ADMINISTRATIVE AMENDMENT (PD) ADD2023-00031

ADMINISTRATIVE AMENDMENT
LEE COUNTY, FLORIDA

WHEREAS, The Shoppes at Verdana Village, LLC filed an application for an administrative amendment to a Residential Planned Development on a project known as The Shoppes at Verdana Village to:

1. Subdivide the neighborhood commercial tract into four (4) separate lots; and
2. Remove site design details from proposed Outparcels 1, 2, and 3; and
3. Update the Commercial Lot Detail on sheet 3 of the MCP (Property Details and Property Development Regulations) to clarify the required front setback for proposed Outparcels 2 and 3; and
4. Add three additional deviations related to internal access and internal buffering; and
5. Remove page 3 of MCP approved by Resolution Z-20-006 since CPA2019-00008 was approved; and
6. Provide an open space table for the Neighborhood Commercial Tract;

- TO ALLOW A 5' TYPE "A" BUFFER
- TO ALLOW THE PRESERVE PLANTINGS TO FUNCTION AS THE REQUIRED BUFFER ALONG THE SOUTHERN, EASTERN, AND WESTERN BOUNDARIES OF THE PROJECT

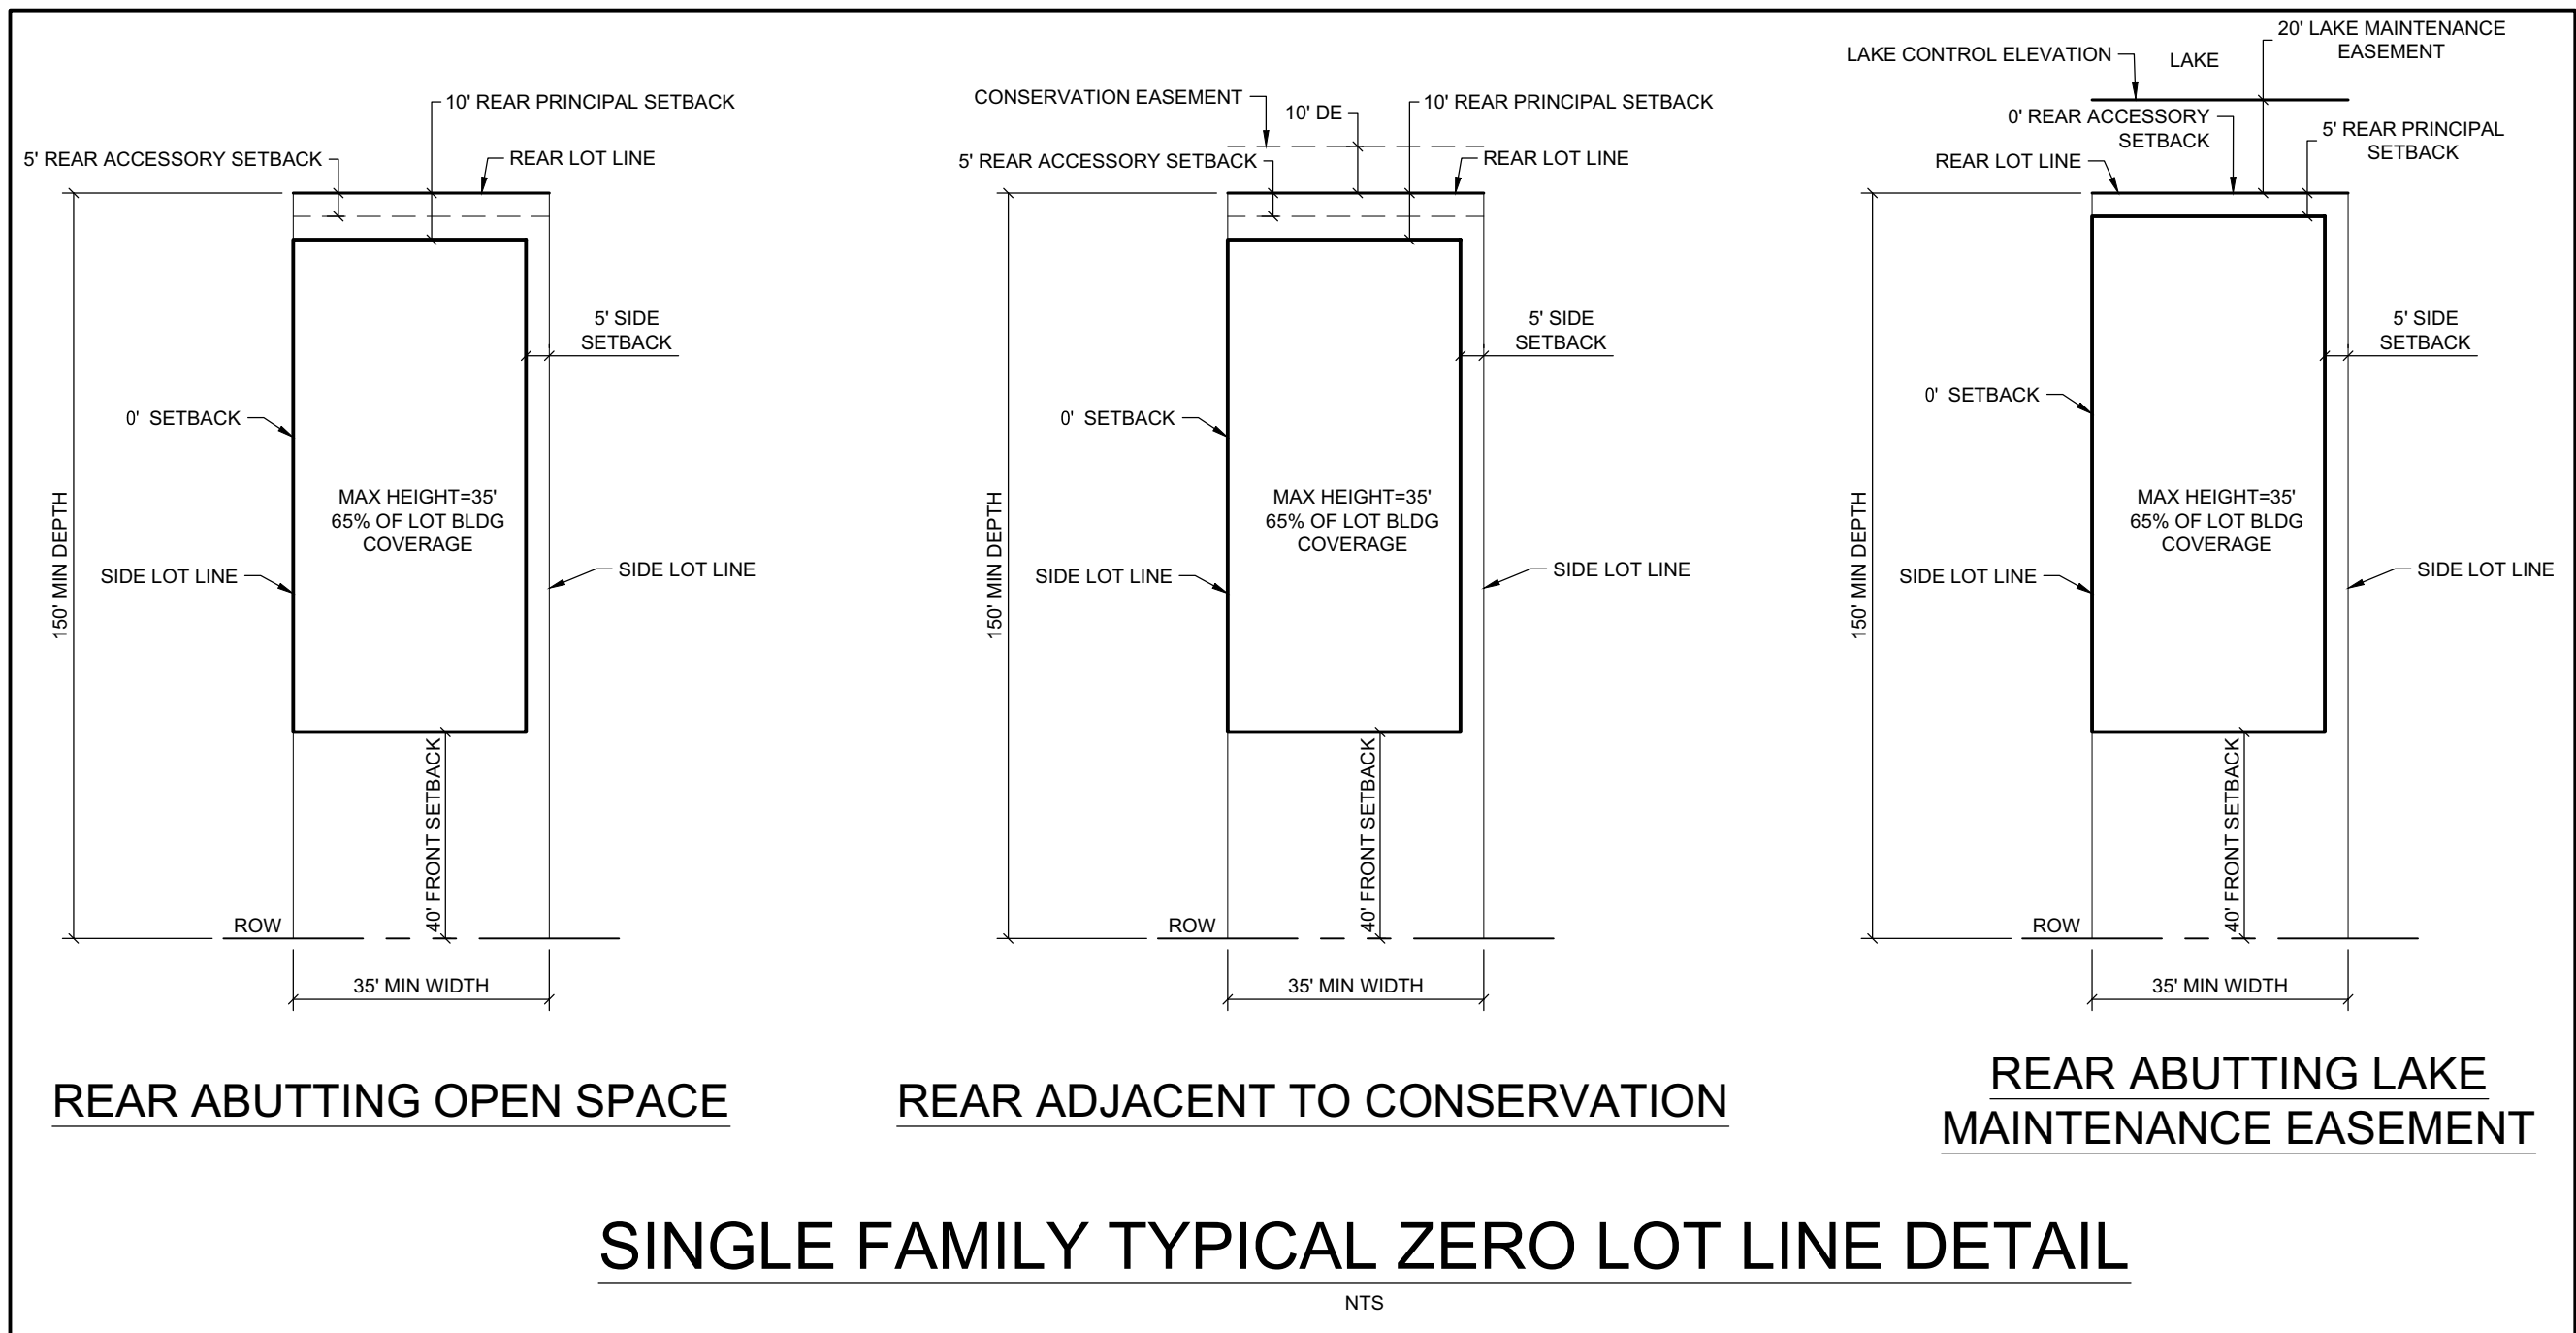
WHEREAS, the applicant has revised the Neighborhood Commercial Tract from one tract to four separate lots and removed the site design details from Outparcels 1, 2, and 3; and

WHEREAS, the applicant has revised the Property Development Regulations to clarify that the front setback for Outparcels 2 and 3 must be 25 feet from the west property line (Exhibit "D" and page 3 of Exhibit "C"); and

WHEREAS, the applicant is requesting this deviation to allow neighborhood commercial Outparcels 2 and 3 to abut and have access to an internal access easement and vehicular circulation without abutting a street designed and constructed to LDC Section 10-296 standards; and

WHEREAS, the applicant is seeking relief to allow no buffers between commercial uses and a three-foot-wide buffer between the commercial uses and the access easement; and

WHEREAS, Development Services staff have reviewed and approved the request subject to a condition requiring a development order to be in compliance with cross section G-G depicted on sheet 4 of the MCP (see Exhibit "C"); and

Prior to local development order approval, the site plans must depict the ingress/egress easement in substantial compliance with cross section G-G per sheet 4 of the Master Concept Plan.

Prior to local development order approval, the plans must depict a three-foot-wide buffer between the commercial uses and the ingress/egress easement. The landscape buffer must include seven-gallon container sized native shrubs specified at 48-inches-in-height and installed four-foot-on-center. The buffer vegetation may be installed in the Lee County Utility easement per Exhibit "F".
